4301 STONE WAY NORTH

DPD LAND USE #3009828 | DPD PERMIT #6197474 | 4301 STONE WAY NORTH | DESIGN REVIEW BOARD SUBMITTAL | 10.8.2010

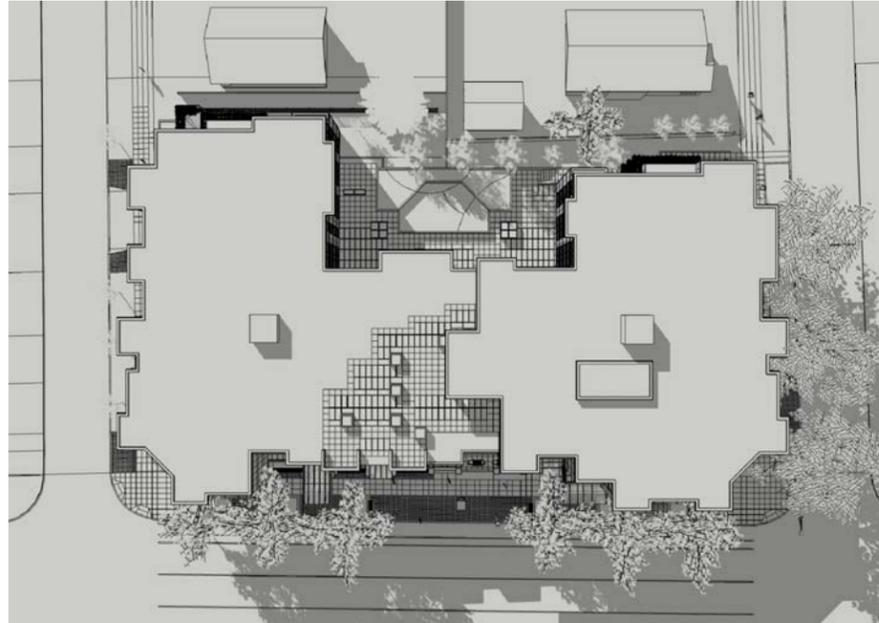
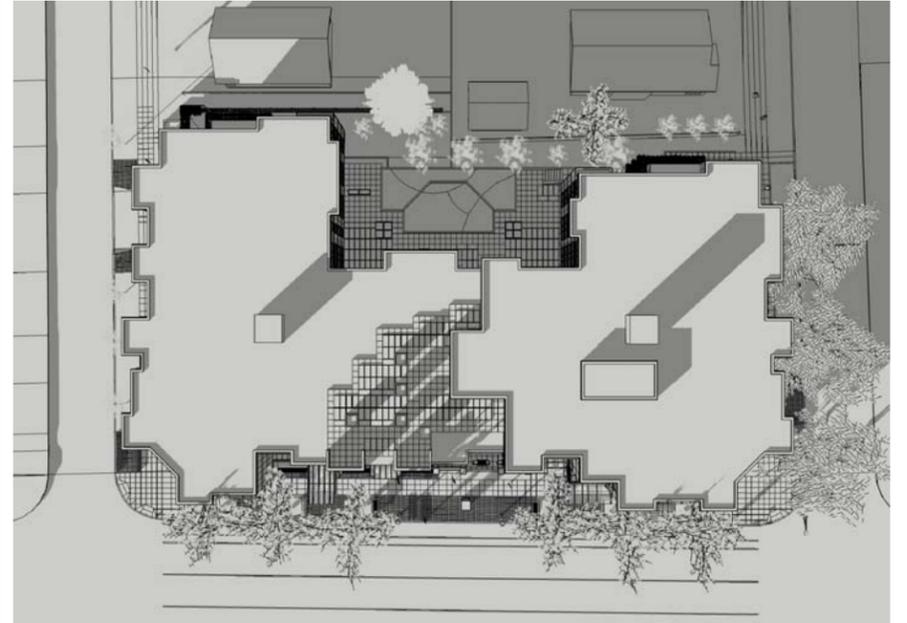
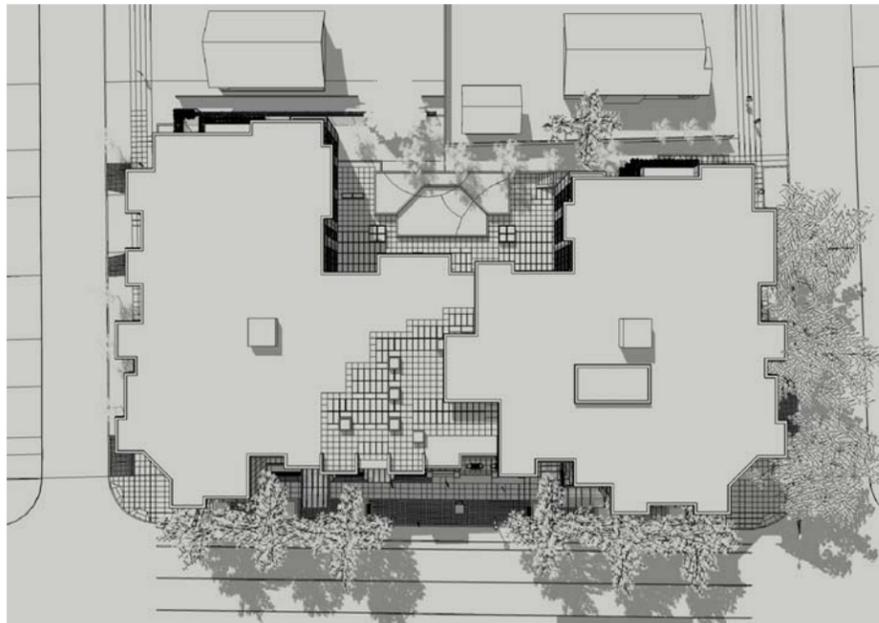
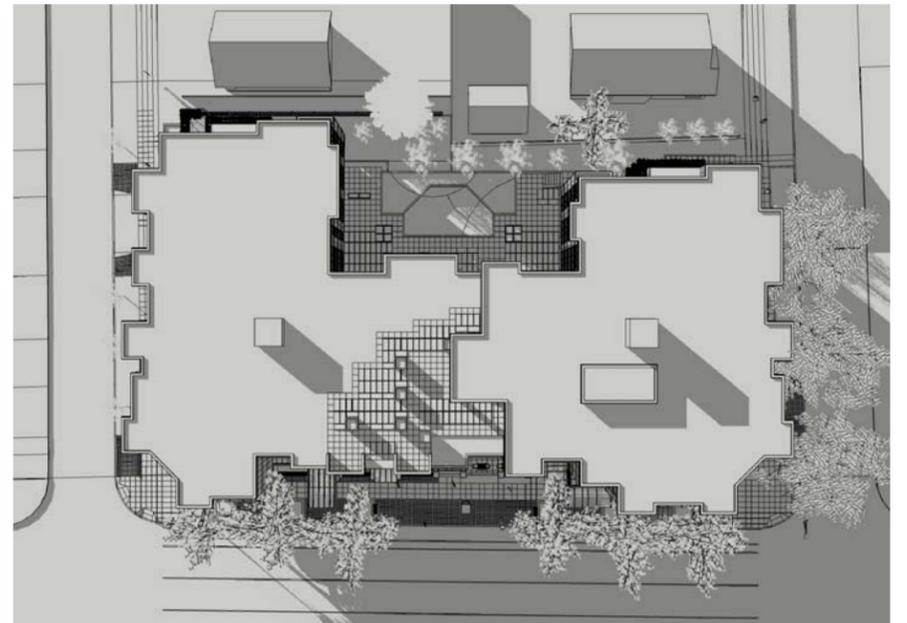
At the Recommendation meeting, the Board expects that all of the proposed open spaces, especially the west facing residential patio, will have accompanying shadow studies to determine the amount and quality of daylight to be received. The existing trees near the west property lines should be integrated into the open space design.

Shadow studies are enclosed and the two existing evergreens near the west property line will be protected during construction.

key plan. 1/4"=1'-0"

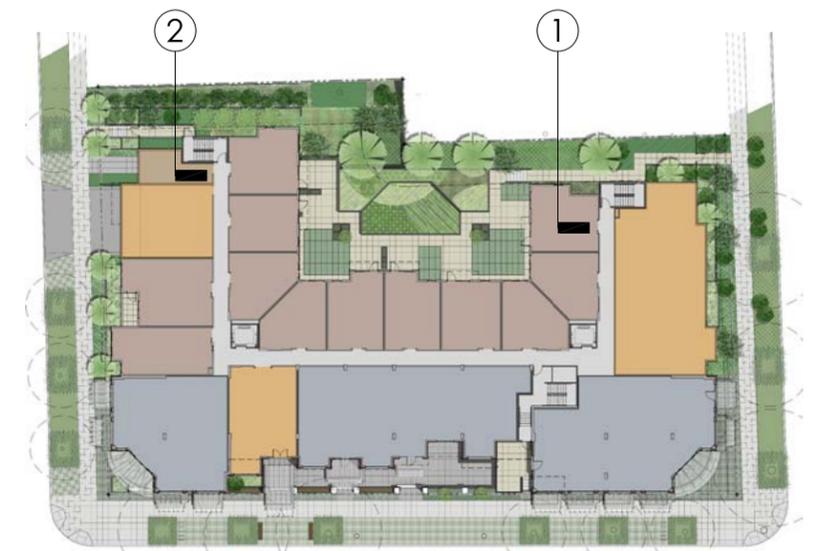
The landscaping may require retaining walls along the west property line. The design of them should exhibit a consideration for quality detail. See Wallingford specific guideline D-3.

At this location, the grade slopes away from the proposed building toward the neighboring residence. A retaining wall is proposed in addition to a green wall and dense landscaping. Planters on the wall of the building will help to soften the building above the first level.

The existing house is 3 feet from the property line and we have located a 4 foot tall fence on the property that will minimize any visual losses and maximize sun for the house. A green screen is then set back off of the property to offer a visual barrier as well as a security wall for the property.
